SUPPLEMENTAL INSTRUCTION

PROJ.: **Boys and Girls Club Prince of Wales**
PROJ. No.: **1716**
DATE: **July 11, 2018**
S.I. No. **S.I. - 036**

Information Bulletin S05-A

Project: BOYS & GIRLS CLUB OF OTTAWA-ADDITION-1463 PRINCE OF WALES DR

TITLE:	SECTIONS 1 & 1A-REVISED TO SUIT AS-BUILT CONDITIONS (REF: DWG S300)
PROJECT:	BOYS & GIRLS CLUB OF OTTAWA-ADDITION-1463 PRINCE OF WALES DR
CLIENT:	HOBIN ARCHITECTURE INC.

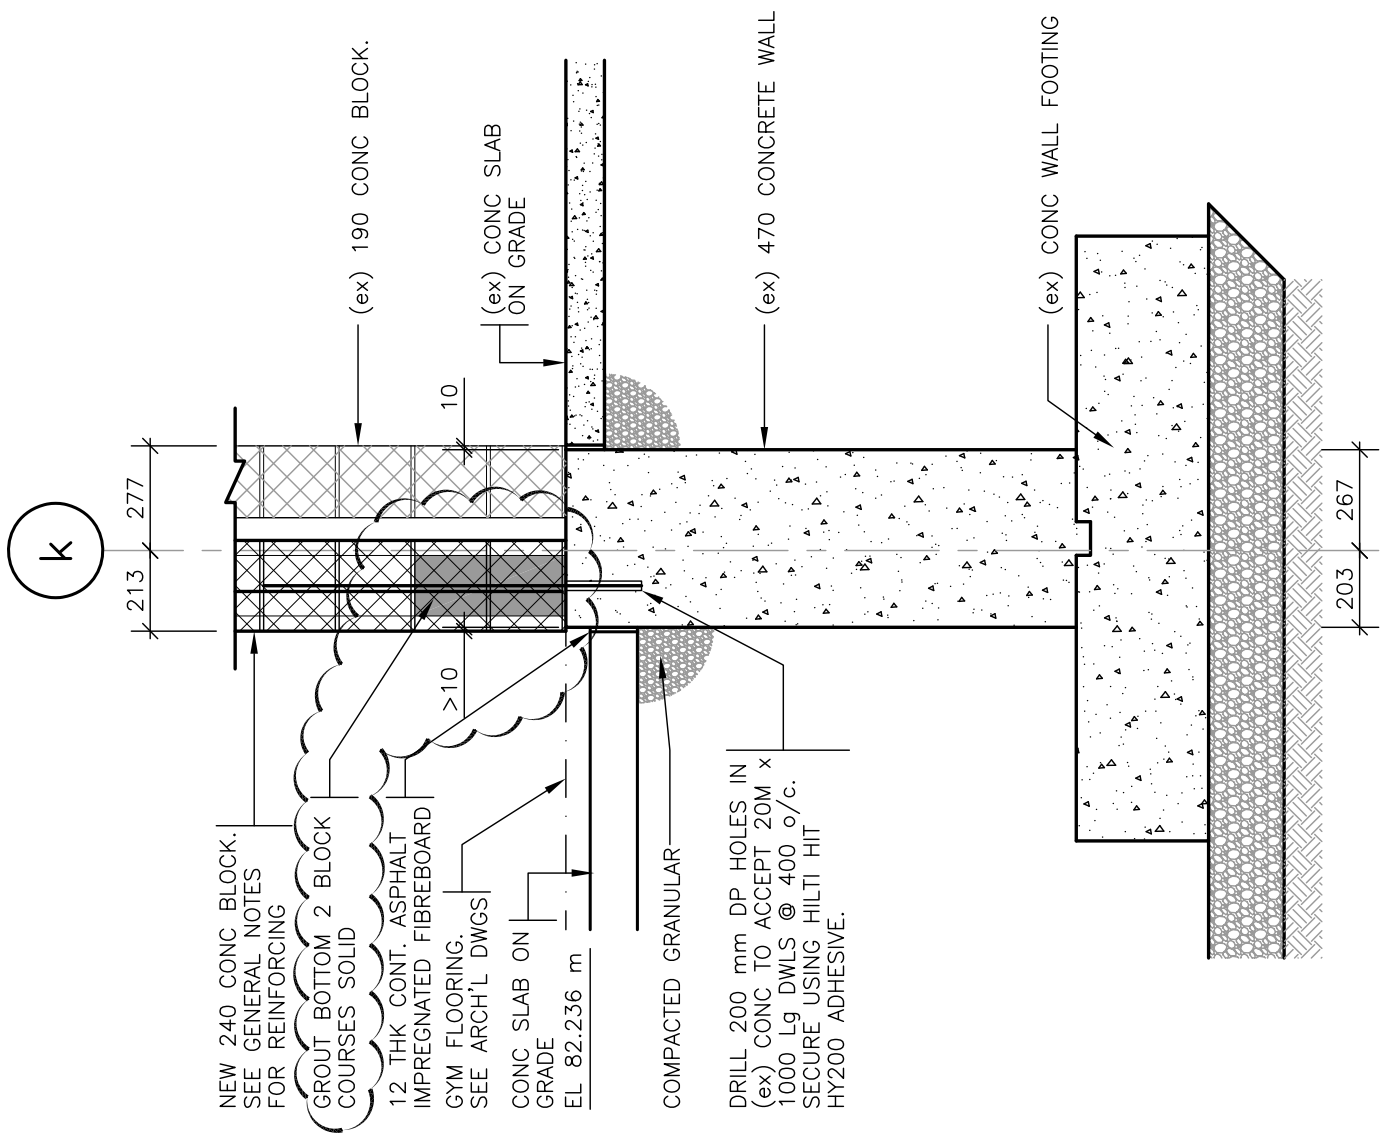
.1 SK6 SECTIONS 1 & 1A-REVISED TO SUIT AS-BUILT CONDITIONS (REF: DWG S300)

The face of the foundation wall on the Phase 2 side of sections 1 & 1A is constructed such that, when the new 240 mm block is installed, the block overhangs the concrete by between 15 mm & 25 mm instead of the originally noted 10 mm. The grouting of the bottom 2 courses of block as noted in SK6 is necessary to accommodate the aforementioned block overhang.

.1 Refer to attached IB-S05-A providing information about filling block courses in location where concrete block overhangs the foundation wall by more than 10mm.
